UNITED STATES PATENT AND TRADEMARK OFFICE

| APPLICATION NO. | FILING DATE | FIRST NAMED INVENTOR | ATTORNEY DOCKET NO. | CONFIRMATION NO. |
|-----------------|-------------|----------------------|---------------------|------------------|
| 10/576,421 | 04/19/2006 | Tetsuya Hayashi | 043888-0447 | 9484 |

| Office Action Summary | Application No. 10/576,421 | Applicant(s) HAYASHI ET AL. | |

The following illustration (modification of Mizutani Figure 1) is provided for clarification:

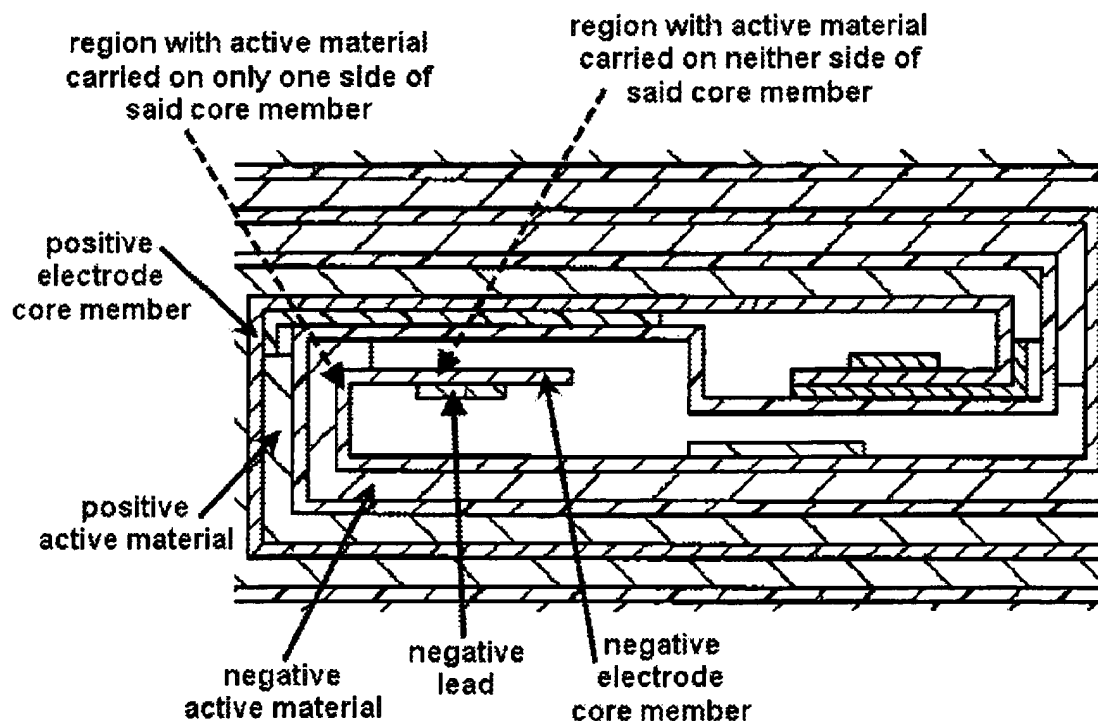
With regard to claims 1 and 3-4, Mizutani et al. teaches a lithium ion secondary battery (paragraphs [0037]-[0038]; Figure 1) including an electrode group that comprises:

a positive electrode comprising a positive electrode core member (15, paragraph [0044]; Figure 1) and a positive electrode active material layer (2, paragraphs [0038] & [0044]; Figure 1) carried on said positive electrode core member (paragraph [0044]; Figure 1),

a negative electrode comprising a negative electrode core member (16, paragraph [0047]; Figure 1) and a negative electrode active material layer (3, paragraph [0038]; Figure 1) carried on said negative electrode core member (paragraphs [0038] & [0047]; Figure 1),

a porous film (1, paragraphs [0038] & [0050]; Figure 1) disposed between said positive electrode and said negative electrode (paragraph [0038]; Figure 1), wherein said positive electrode and said negative electrode are wound (paragraph [0038]; Figure 1), and wherein said negative electrode has, on the initial winding side, a region where said negative electrode active material layer is carried on neither side of said core member (paragraph [0056]; Figure 1) and an adjoining region where said active material layer is carried on only one side of said core member (paragraph [0038]; Figure 1), and

a lead (9, paragraphs [0038] & [0056]; Figure 1) provided in the region of negative electrode where the active material layer is carried on neither side of said core member (9, paragraphs [0038] & [0056]; Figure 1).
